ONONDAGA COUNTY PLANNING BOARD

Wednesday, July 23, 2025
11:00 AM

MEETING AGENDA

SKETCH PLAN
A.J.D.
1" = 30ft
24" x 36" P. SIZE
11.25.2024
A-1

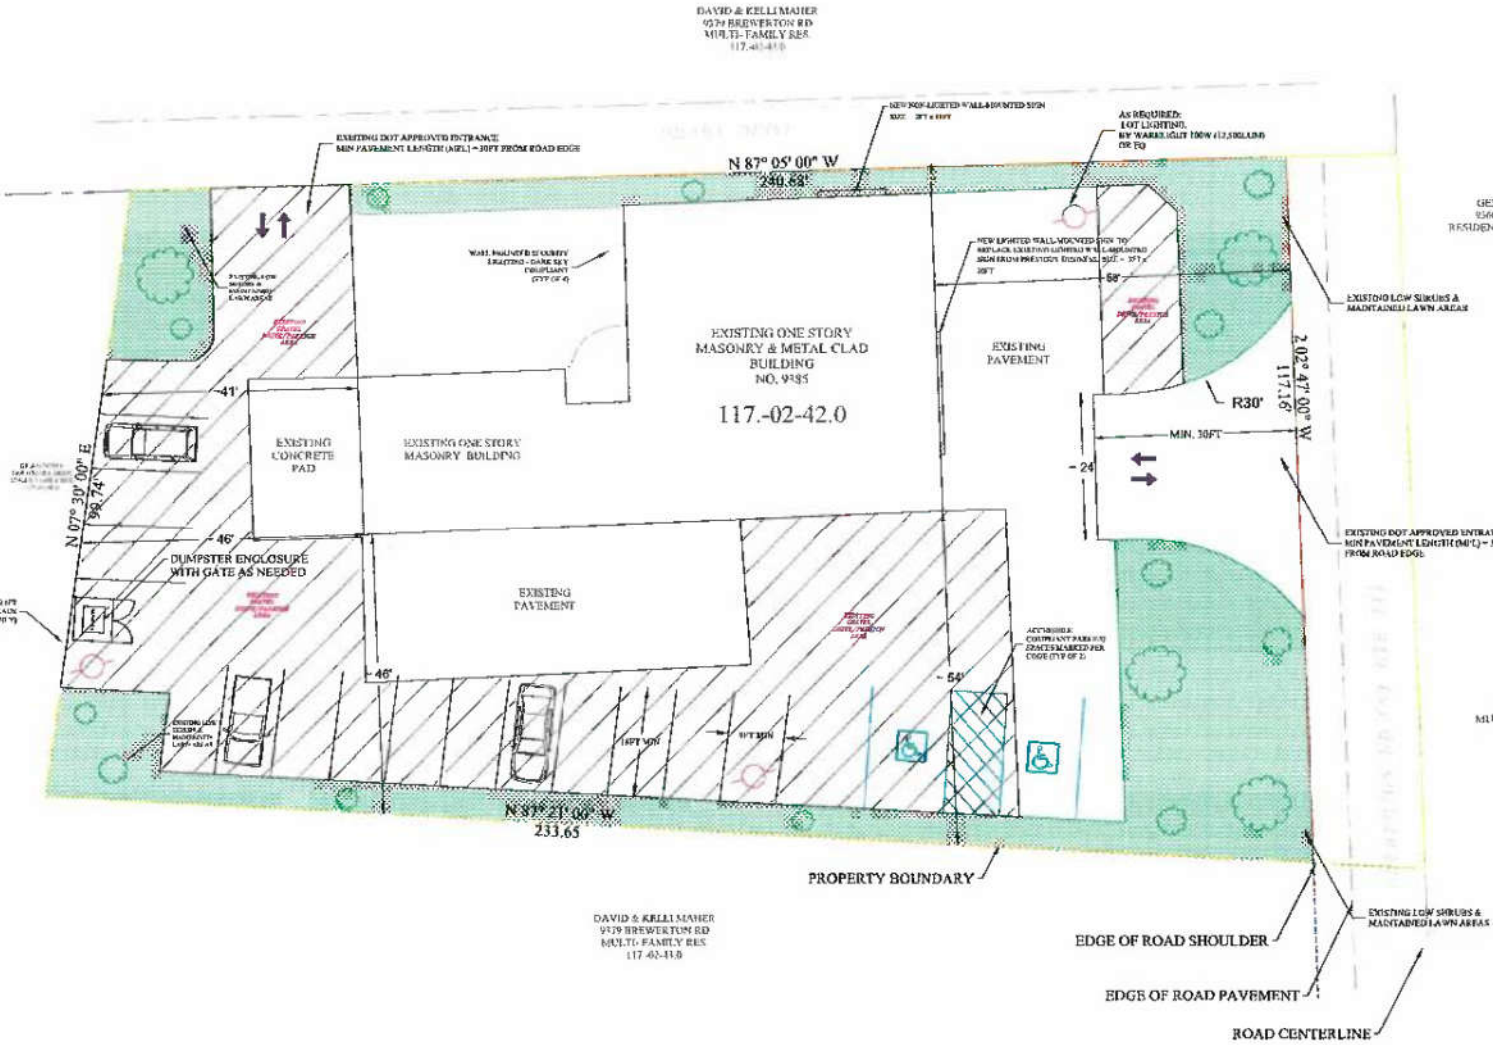
the applicant is proposing to convert the site for use as a construction and contracting business; per an email from the Town dated 7/14/25, the referred site plan had been approved previously, but improvements shown on that plan were either never completely implemented or not maintained; the applicant will be completing these improvements as part of the current site conversion; per the Sketch Plan dated 11/25/24, the eastern driveway to Omara Drive (closest to the intersection) will be closed and landscape strips will be installed along the road frontage; the driveway and parking lot, currently either gravel or degraded pavement, will be repaved and striped; the landscaped area along the Brewerton Road frontage will be re-established and low shrubs installed; a dumpster enclosure will be constructed at the rear of the site; additional site improvements include interior building alterations, façade improvements, and the addition of signage to the Brewerton Road-facing side of the building; light poles area shown near the northeast corner, southwest corner, and along the southern parcel boundary with the note “lighting shall not be direct at NY RTE 11 or adjacent lands”; the Sketch Plan shows the western parking area extending to the western parcel boundary with no setback; ADVISORY NOTE: Per the NYS Department of Transportation, all existing or proposed driveways on Brewerton Road must meet Department requirements; and

per the Environmental Assessment Form (EAF) dated 7/2/25, zero acres of the site will be disturbed by the proposed project, however it appears new area of the pavement will be added; and

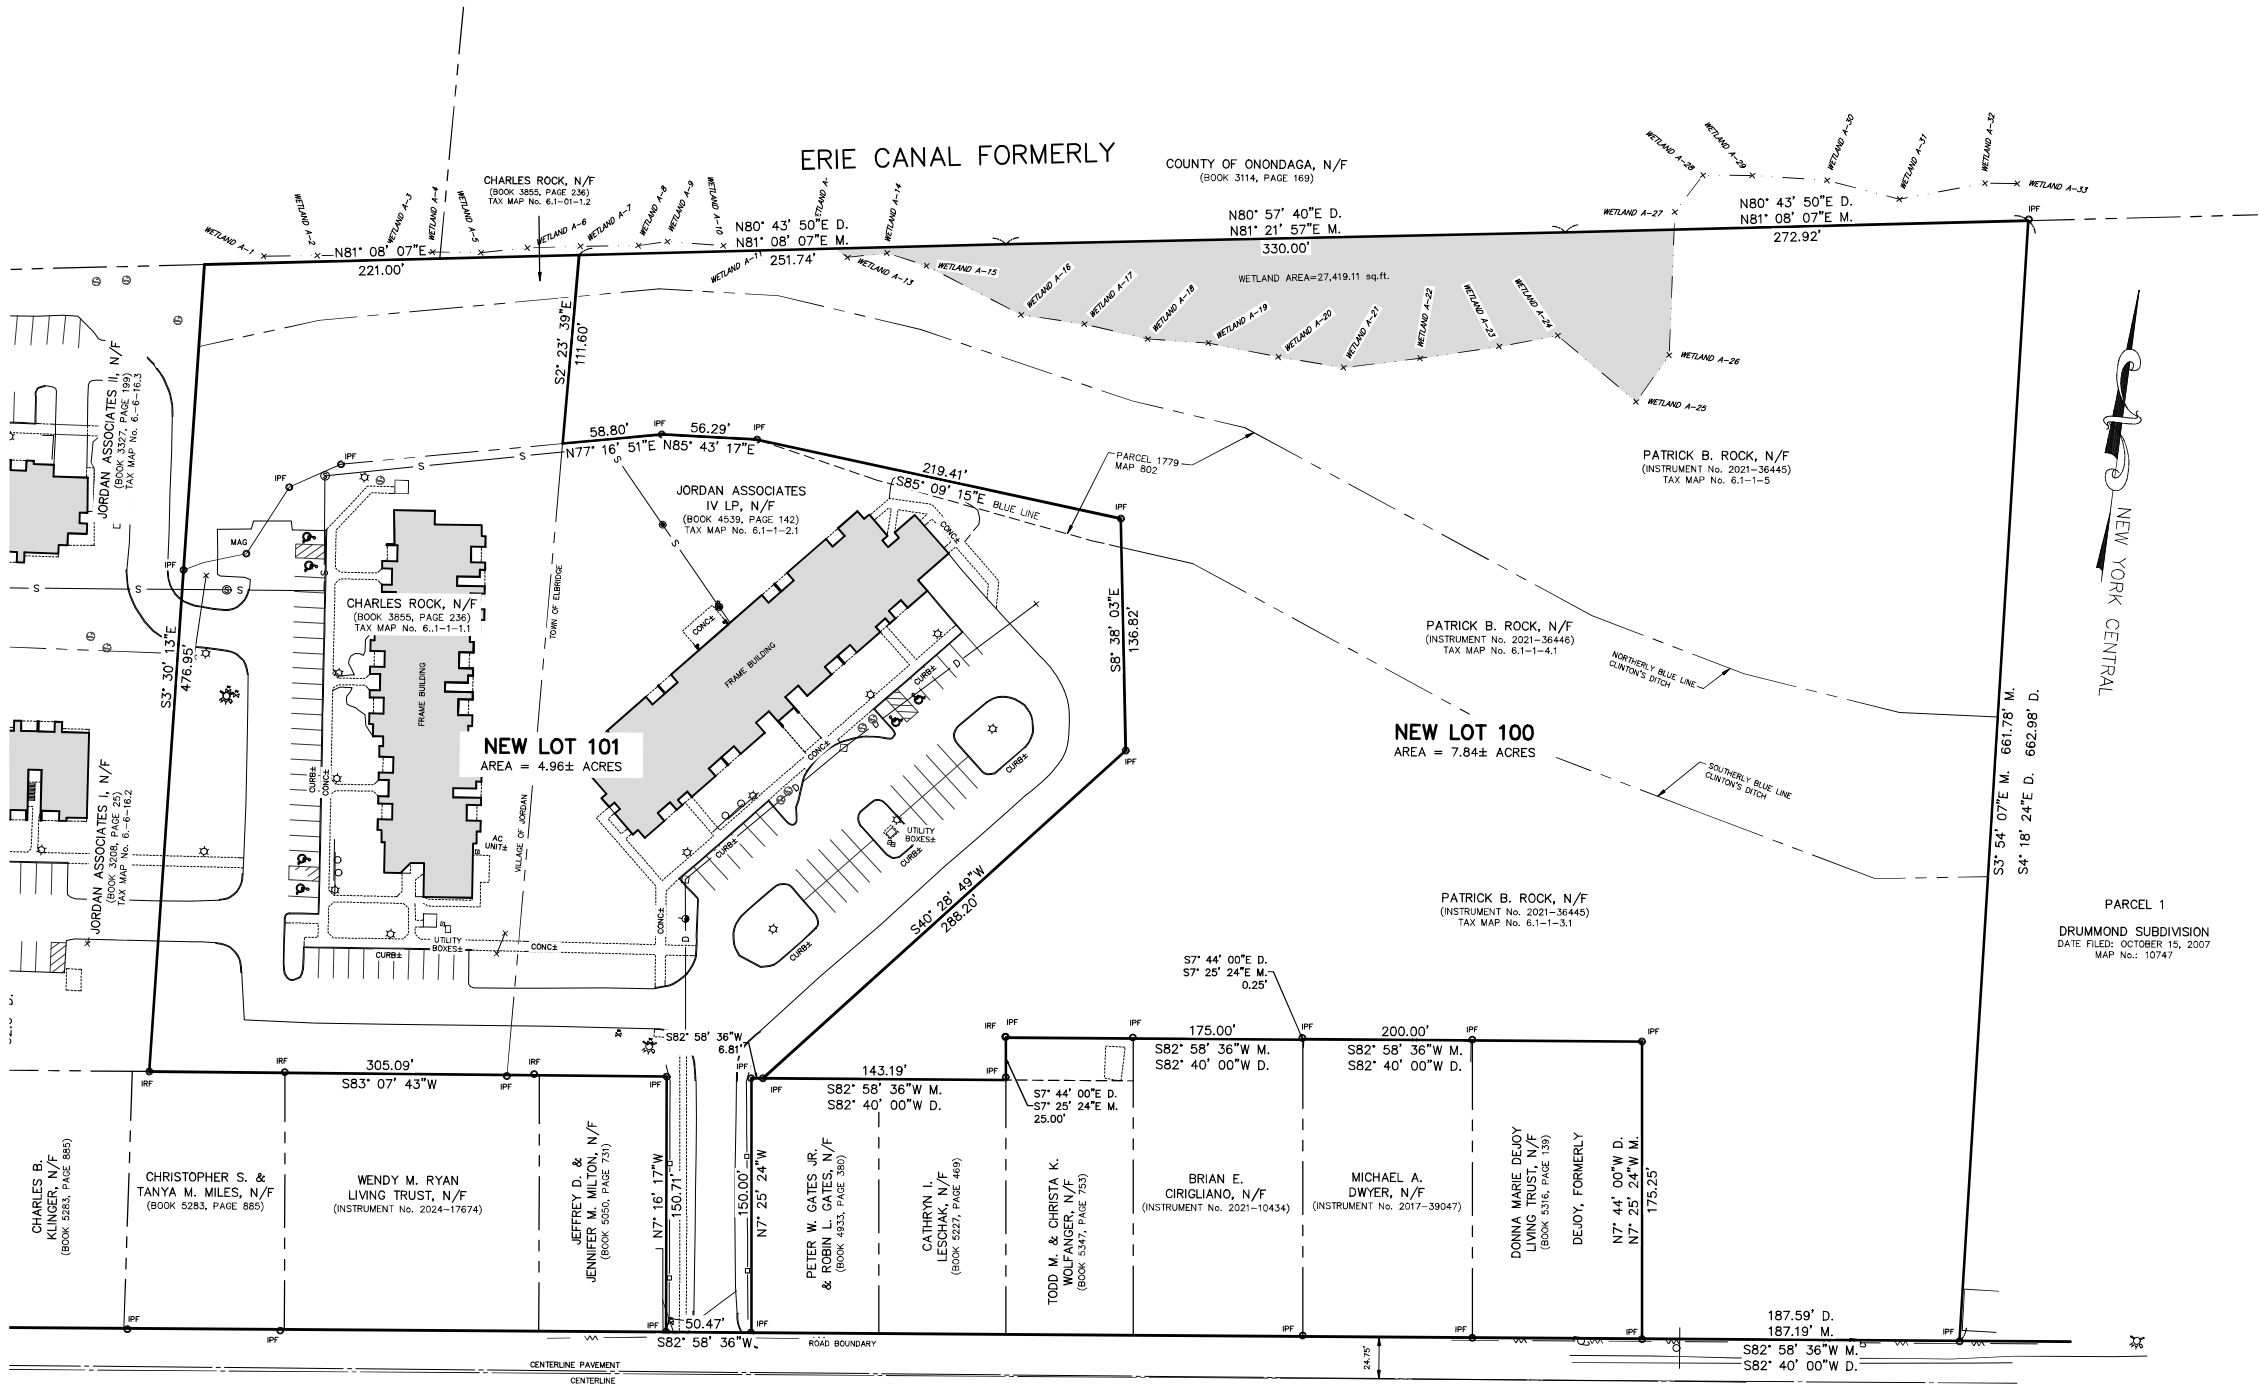
- 5 per the Lands Of Rock Final Plan dated 5/29/25, the applicant is proposing to combine the six parcels comprising the site into two new lots; New Lot 101 will be 4.96 acres and will contain two of the existing apartment buildings and the full access driveway to Peru Road, a county highway; New Lot 100 will be 7.84 acres and will contain the new development and 188' of frontage on Peru Road;
ADVISORY NOTE: Any proposed driveway onto Peru Road requires highway access and work permits from the Onondaga County Department of Transportation; and

OVERALL
PLAN

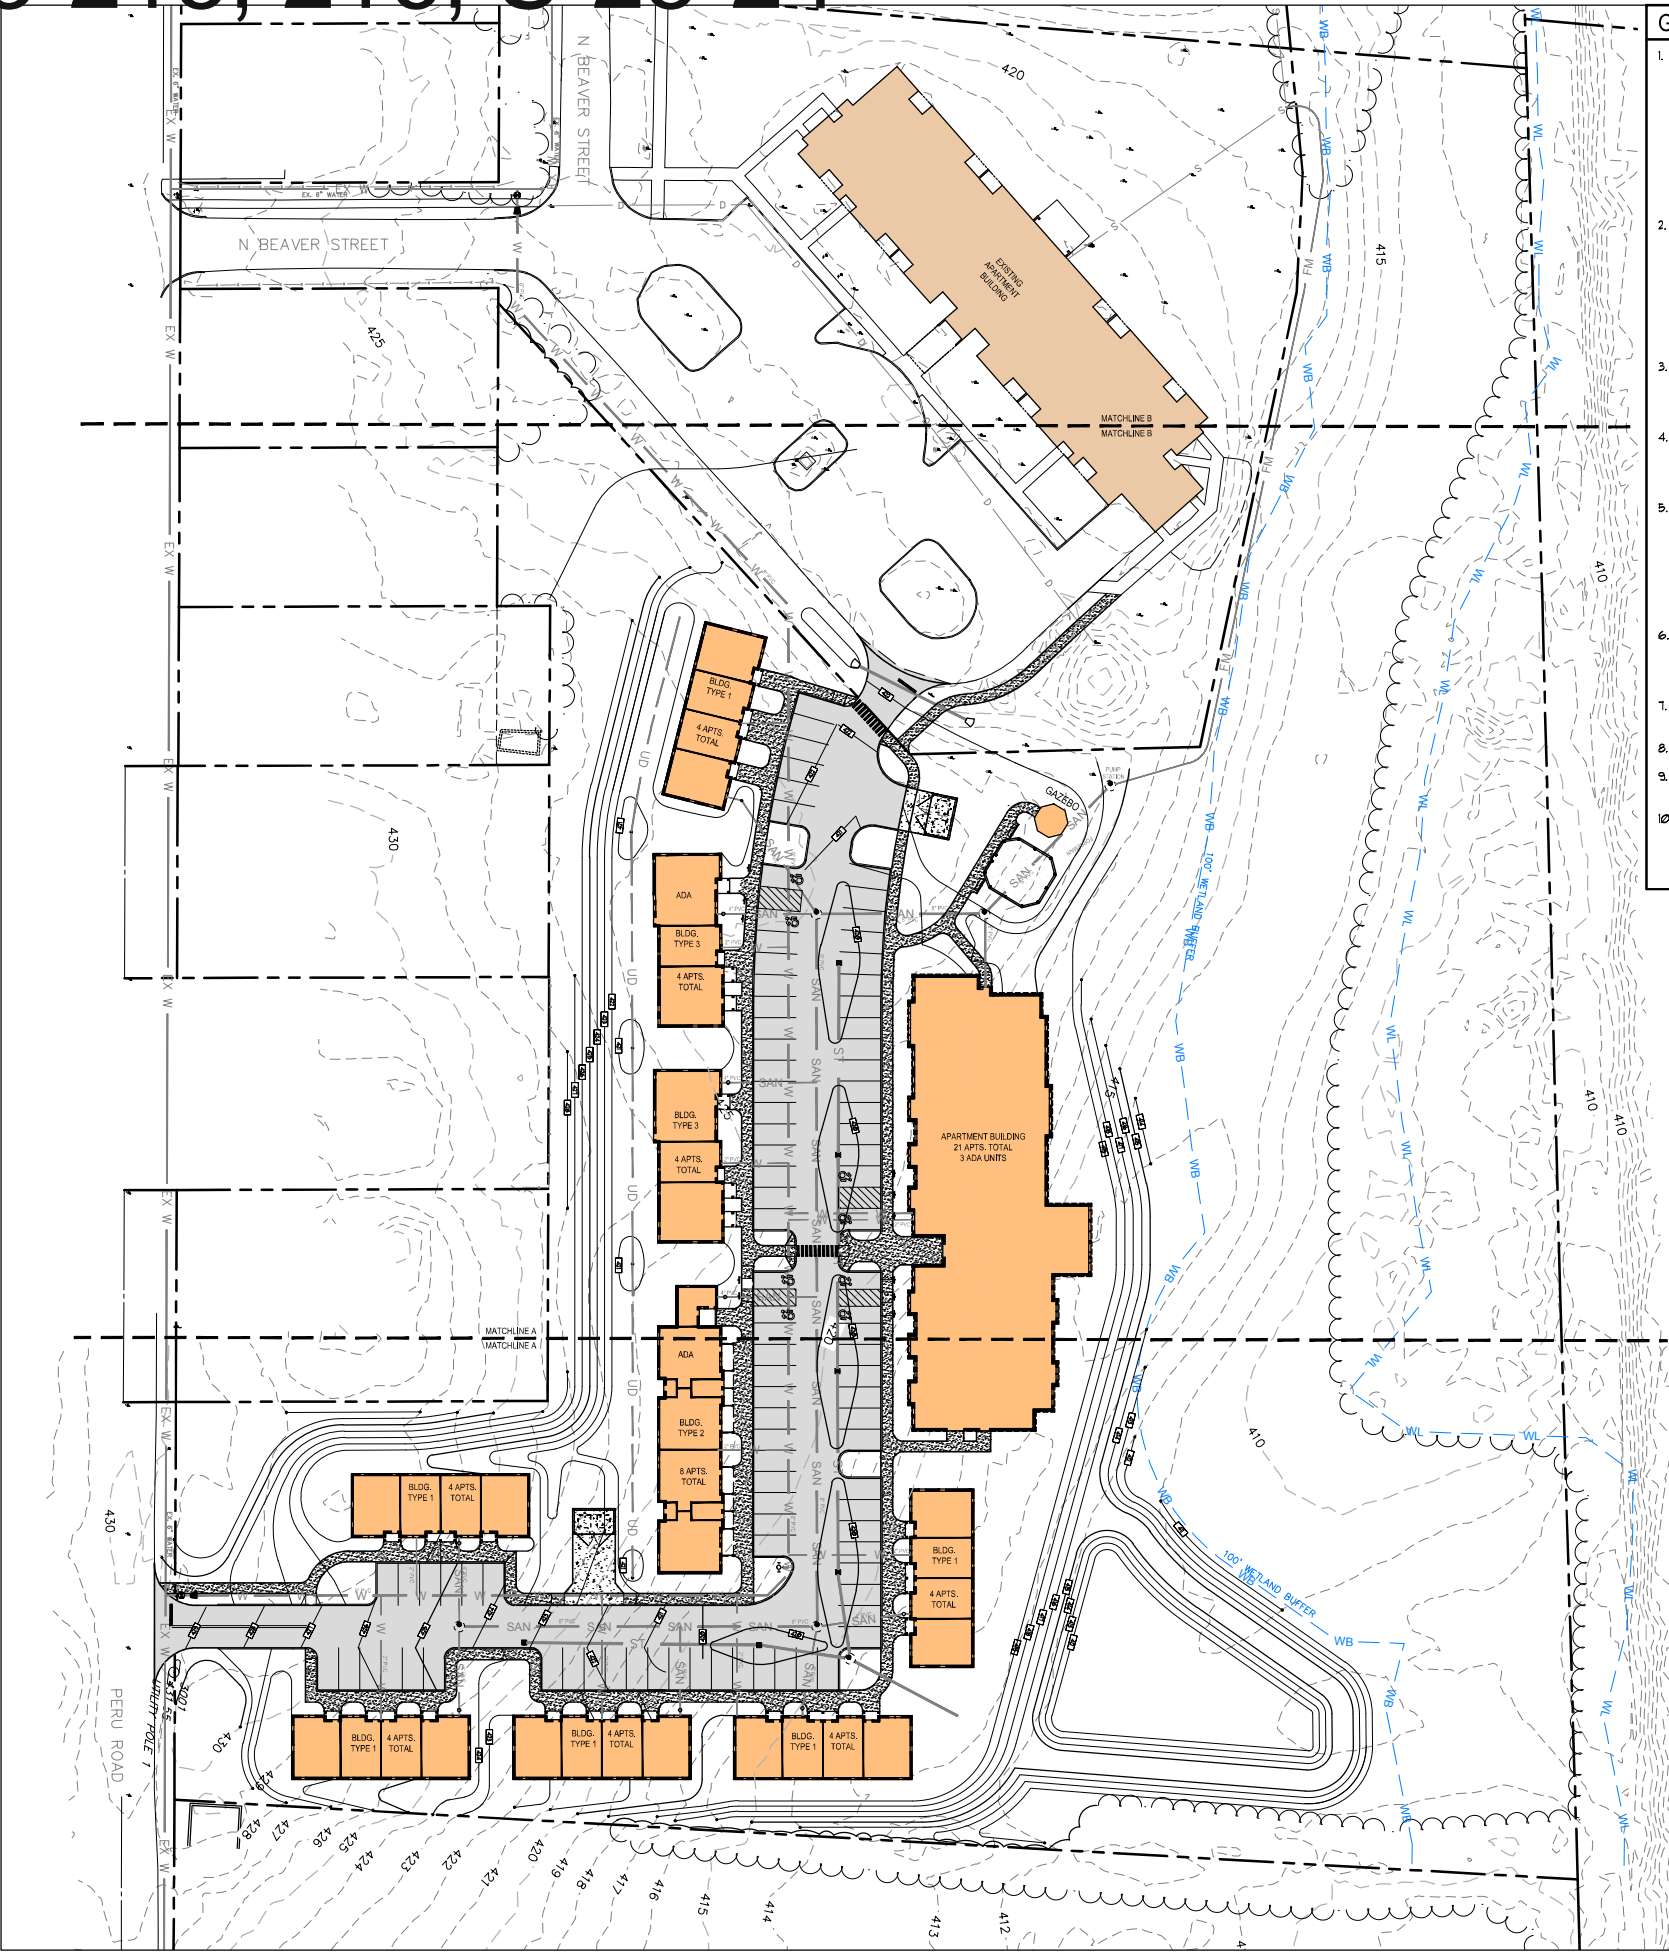
- 6 per the Overall Plan dated 5/7/25, the applicant is proposing a multi-building apartment complex to be arranged on an internal road, extending from Peru Road and connecting the existing complex to the west; a 21-unit, 2-story apartment building will be located between the internal road and the rear of the site; nine smaller, 1-2-story buildings containing 4 to 8 apartments each (totaling 40) will also line the internal road; 61 total apartments are indicated on the plans, but 65 are proposed on the referral notice and in the Environmental Assessment Form (EAF) dated 5/7/25; 84 parking spaces line the internal road; sidewalks line the internal road and connect to Peru Road and sidewalks at the existing apartment building; two dumpster enclosures are shown and a gazebo is proposed adjacent to the large apartment building; per the EAF, amenities will include a gym, community room, and playground; a Site Planting Plan dated 5/7/25 was included with the referral materials which details various plants, shrubs, and trees but they are not indicated on the plan so the quantity and location of proposed plantings is unknown; and

8 per the Environmental Assessment Form (EAF) dated 5/7/25, 3.96 acres of the site will be disturbed by the proposed project and stormwater will be directed to "onsite stormwater management facilities"; per the Overall Plan, stormwater infrastructure will be located under the internal road and parking and a stormwater basin is proposed for the northeast corner of the site;

13 the site is located adjacent to the Empire State Trail; the site plan does not reflect connections to this amenity; and
